January 27, 2012

Re: **TRI-COUNTY COUNCIL / SHORE TRANSIT BUS MAINTENANCE FACILITY**
PHASE II
Salisbury, Maryland
2009145.00

ADDENDUM THREE

SHEET: S01

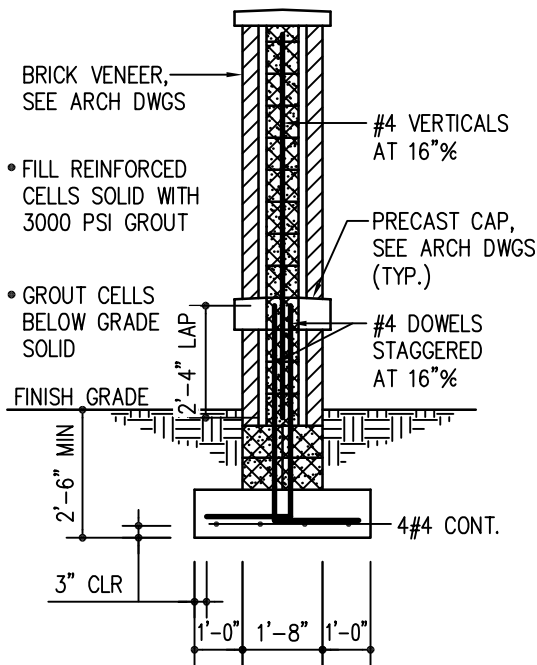
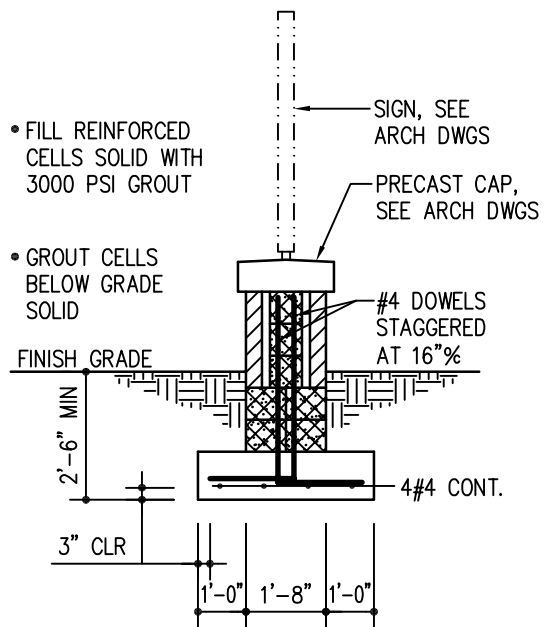
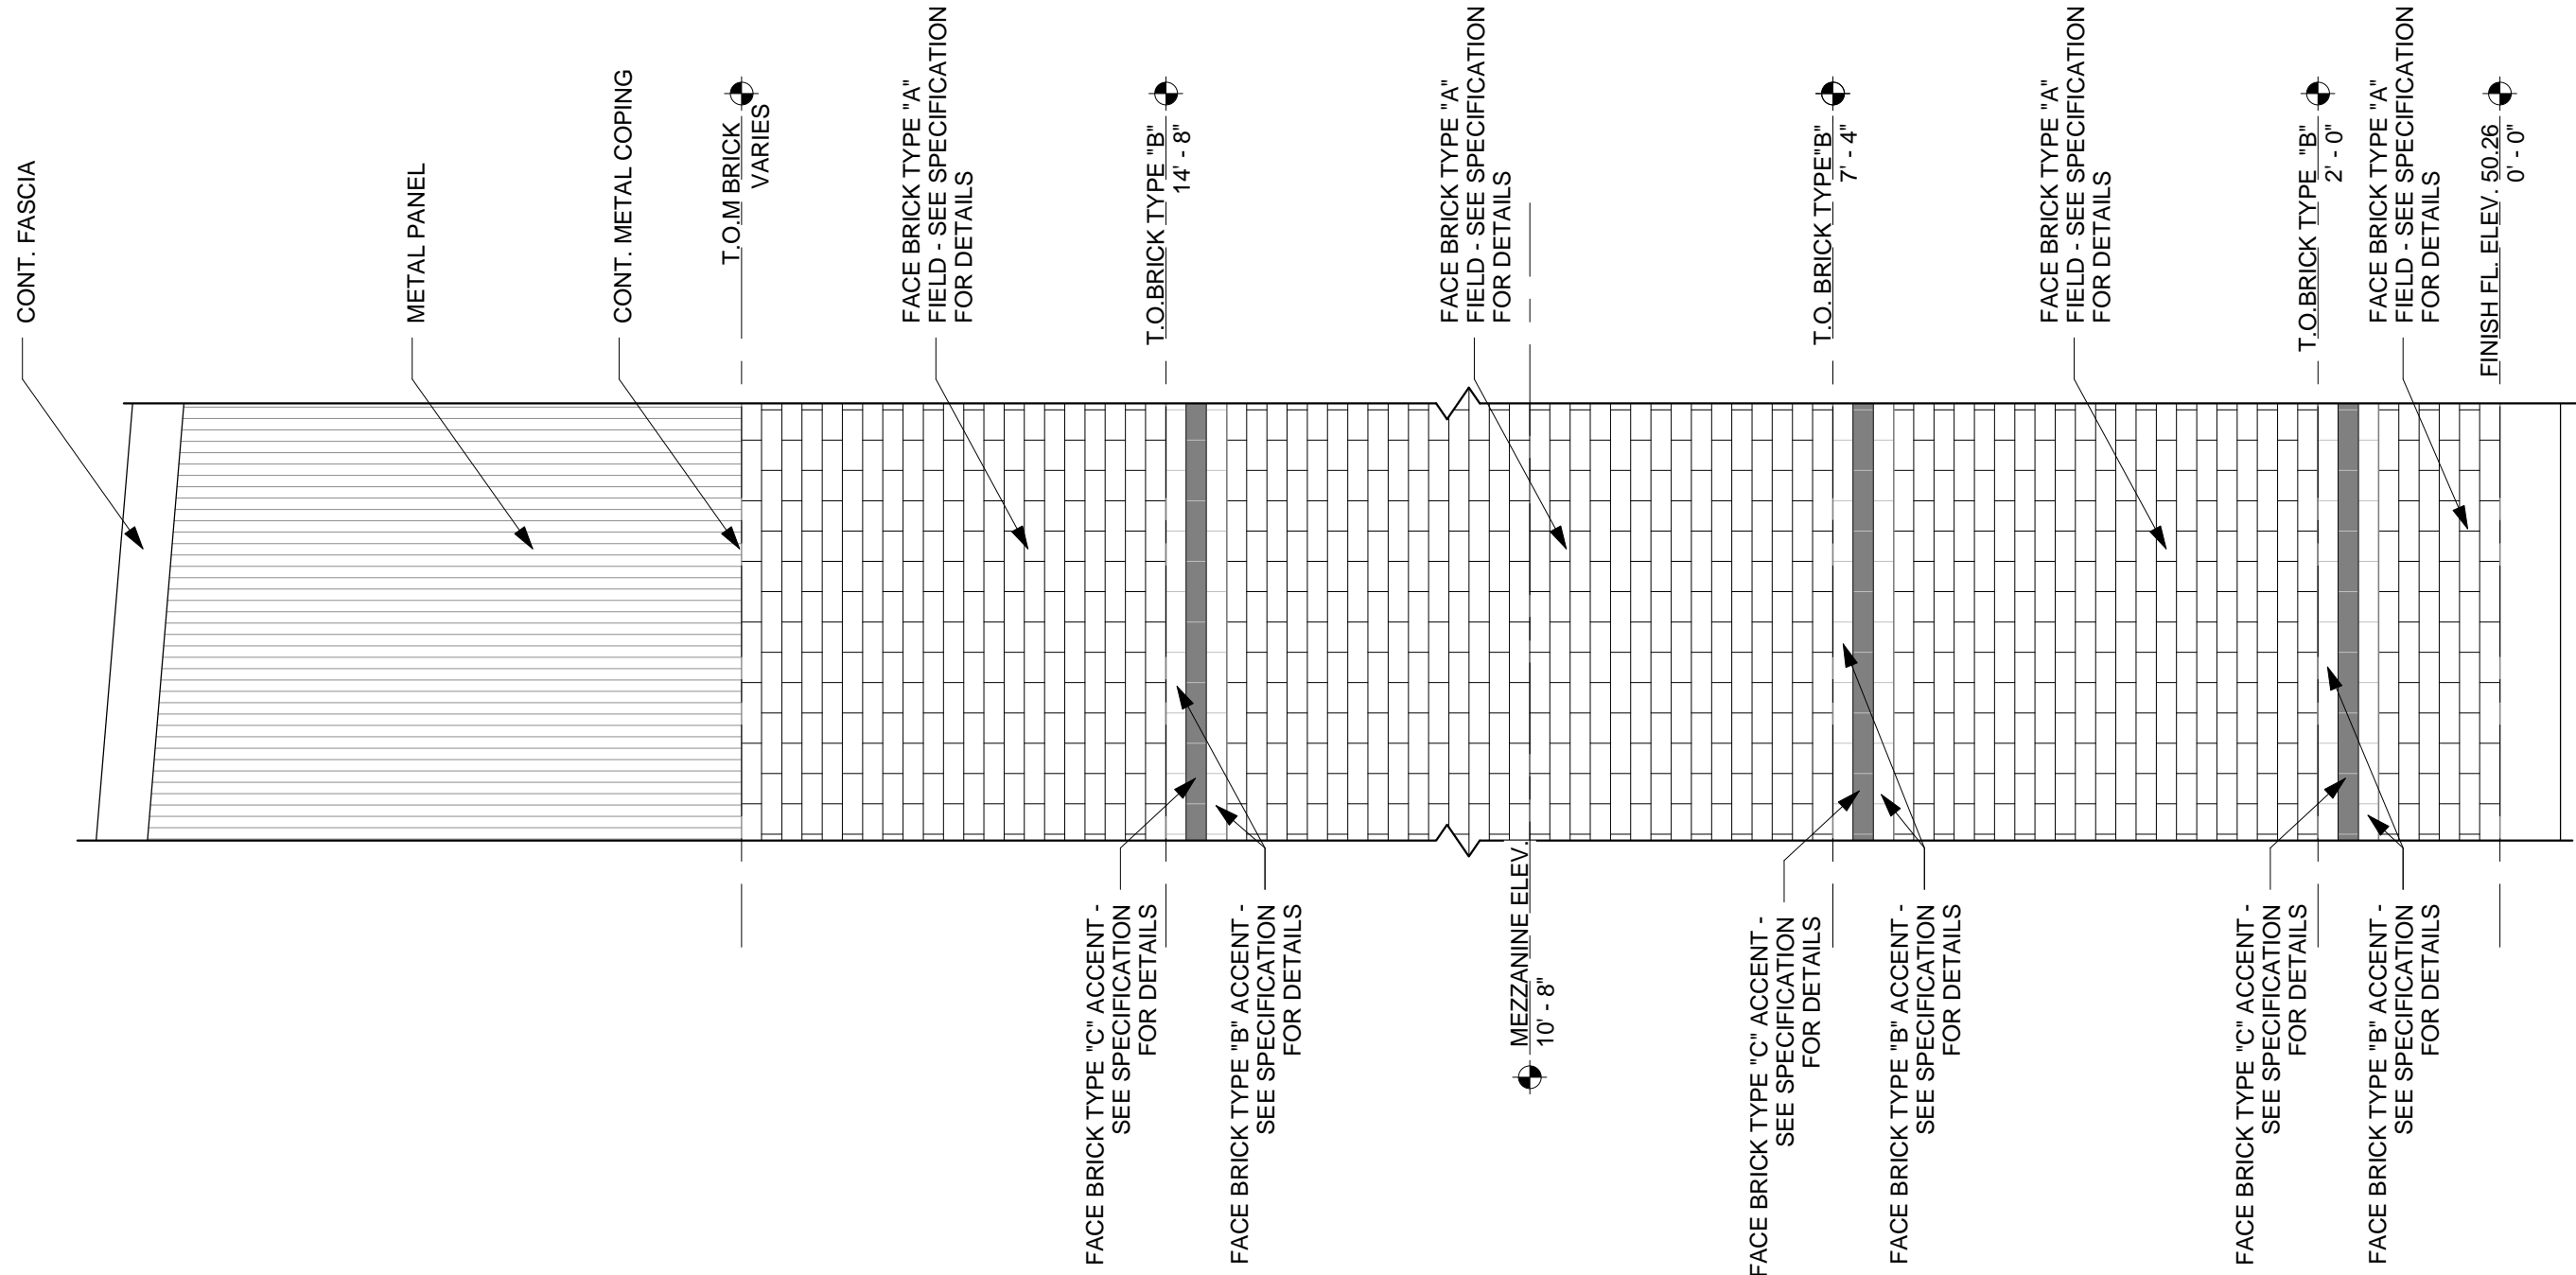
- a. Delete - Detail 3/A503, Sign #2 is no longer included in project
 - b. Coordinate Details 4&5/A503 with Morabito Consultants Inc. sketch sheet S01 dated 1/26/12 issued via Addendum #3.

5. Acceptable manufacturers for cast stone cap at site sign (details 4&5/A503 see also bidders/questions and answers question #9 issued via this addendum) are as follows:

E201

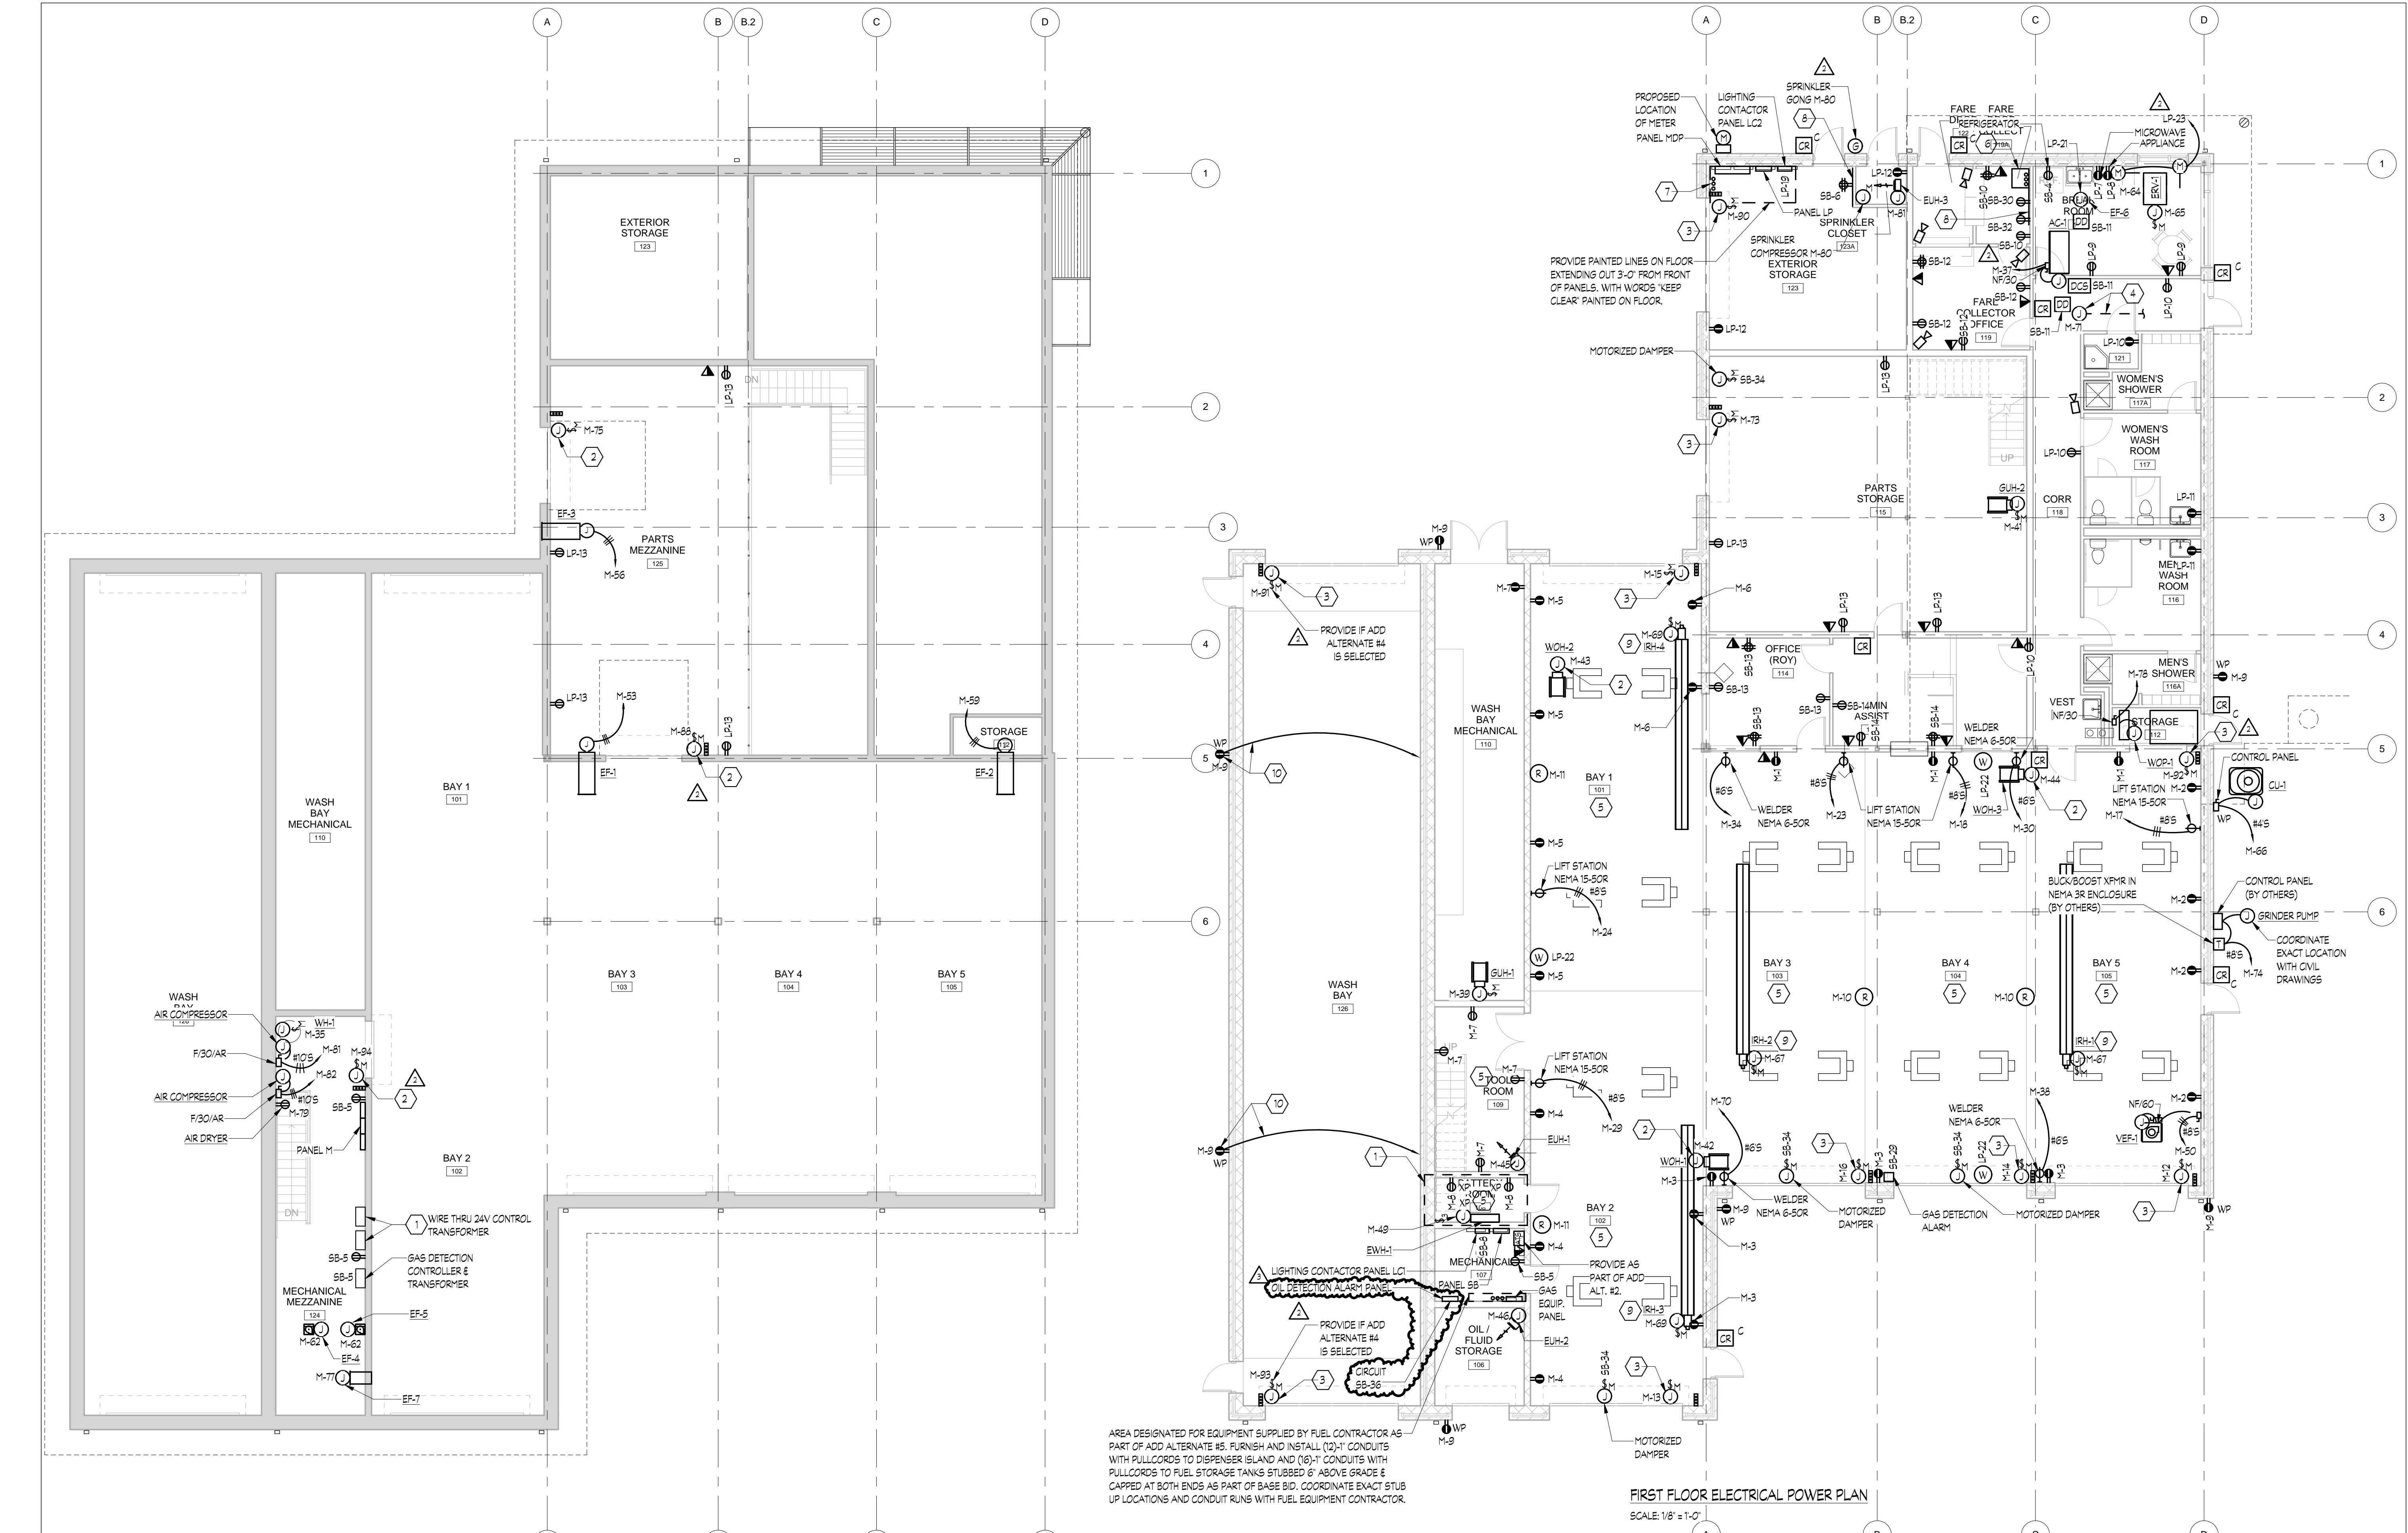
46	A&S	Note 6 on Drawing “E201” and Note 4 on “E301” reference two (2) 3” conduits from the Office Building to the Maintenance Building. One is to have interduct installed; please specify the size and quantities of innerducts that are to be installed in the one 3” conduit.	See response – additional RFI questions received from contractors # 8 from Allen & Shariff Engineering RFI log dated 1/26/12 that is issued via addendum #3	n/a
47	BMG	The wage scale on this project for an electrician is \$37.38 (26.06 + 11.32). Please explain how the wage rate on the site improvement contract that was awarded about 3 months ago for this same facility was \$33.82 (22.50 + 5%+ 10.20)?	Wage rates in spec. are correct. Wage rate in site improvements was for “heavy construction” where as current wage rates are for “building construction”	00
48	MC	Detail 3 on S401 shows window assembly in line with structural beam and masonry, section 1 on A301 shows masonry finish at sills and jambs of window assembly yet 1 on A304 shows windows in front of structural beam, metal stud framing, and drywall finish? Please clarify your intent.	Section 1/A304 corresponds with Section 1/S402 not 3/S401. The placement of the window shall be advised by the architect in addendum #4.	n/a

8. Note 6 on Drawing "E201" and Note 4 on "E301" reference two (2) 3" conduits from the Office Building to the Maintenance Building. One is to have interduct installed; please specify the size and quantities of innerducts that are to be installed in the one 3" conduit.

8. Provide two 1" interducts in the 3" conduit indicated to have interduct installed within.
